TRANS/WP.29/722

World Forum for Harmonization of Vehicle Regulations (WP.29)

DRAFT SUPPLEMENT 3 TO THE 03 SERIES OF AMENDMENTS TO REGULATION No. 44

(Child restraints)

Figure 1 : Truncated P10 manikin block
Material: EPS (40 to 45 g/l)

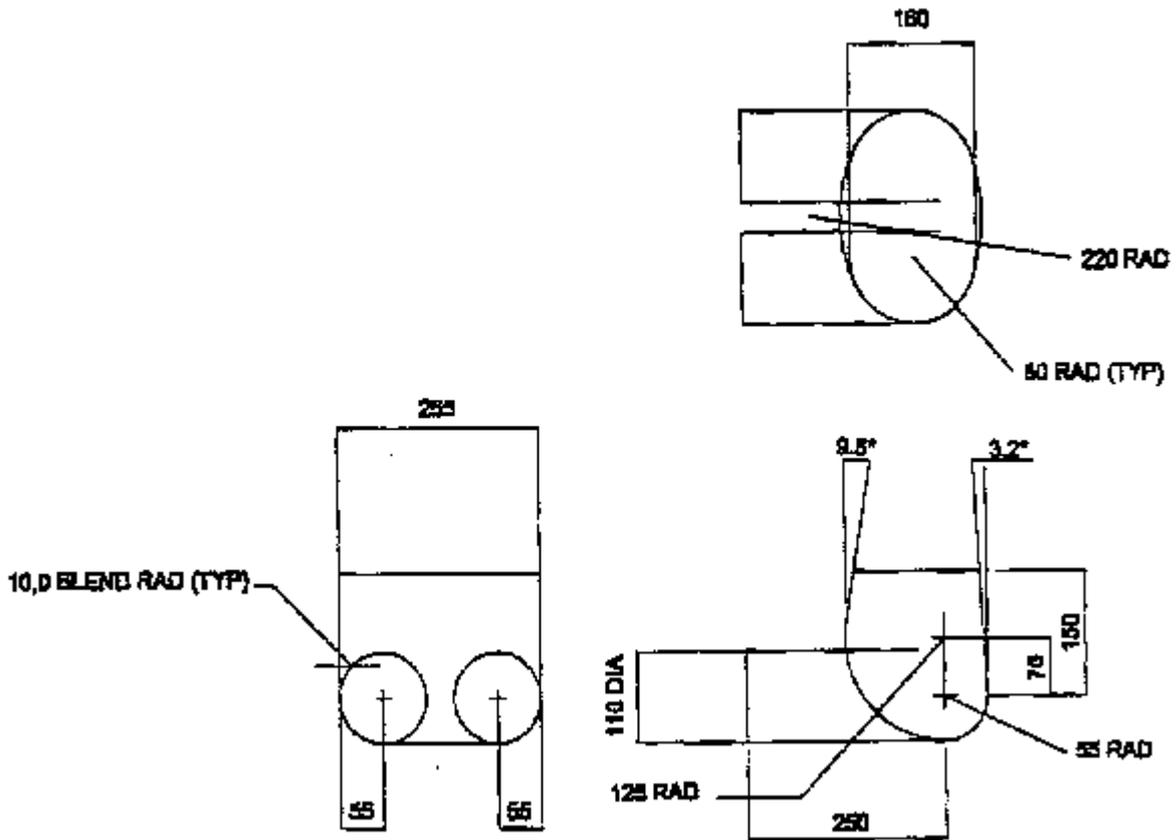
Place a cotton cloth on the seating surface of the test bench. Position the booster cushion on the test bench, position the lower torso body block as described in annex 22, figure 1, on the seating surface, fit and apply the 3-point adult safety-belt and tension as prescribed in annex 21. With a piece of 25 mm width webbing or similar tied round the booster, apply a load of 250 ± 5 N in the direction of arrow A, see annex 22, figure 2, in line with the seating surface of the test bench."
